APPLICATION NO.	FILING DATE	FIRST NAMED INVENTOR	ATTORNEY DOCKET NO.	CONFIRMATION NO.
10/806,718	03/23/2004	Michael Joist	1689.007US1	2652

Office Action Summary

**** Claim(s) 1-4 and 6 are rejected under 35 U.S.C. 102(e) as being anticipated by Stathopoulos et al. (6494729).**

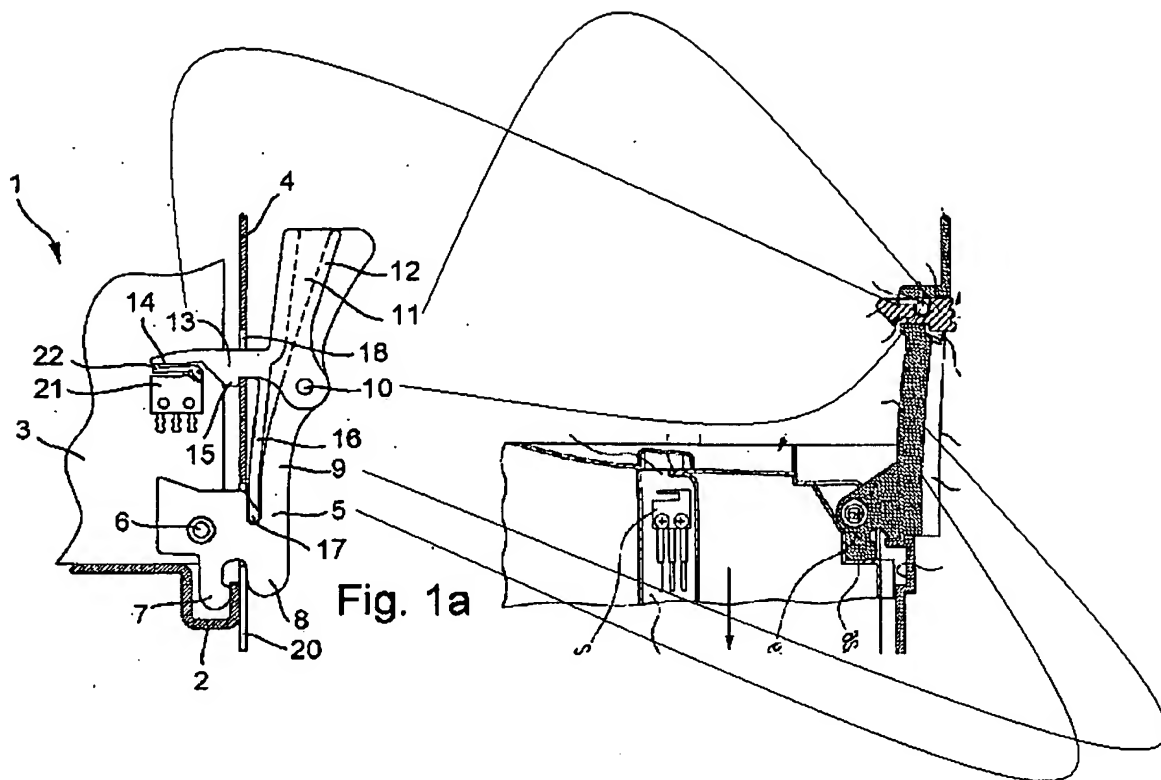
-- In reference to Claim(s) 1, Stathopoulos shows (see examiner's figure)

a circuit board;

a switch for active-passive switching of the plug-in module; and

a swivel-mounted lever/pull handle (see examiner's figure) with located in a frontal area of the plug-in module, the lever/pull handle including a gripper arm which is an integral part of the lever/pull handle; and

a control lever (see examiner's figure) which is rotatably connected to the gripper arm (see examiner's figure) of the lever/pull handle, wherein the control lever includes a stepping

pawl (see examiner's figure) to operate the switch when the plug-in module is completely inserted.
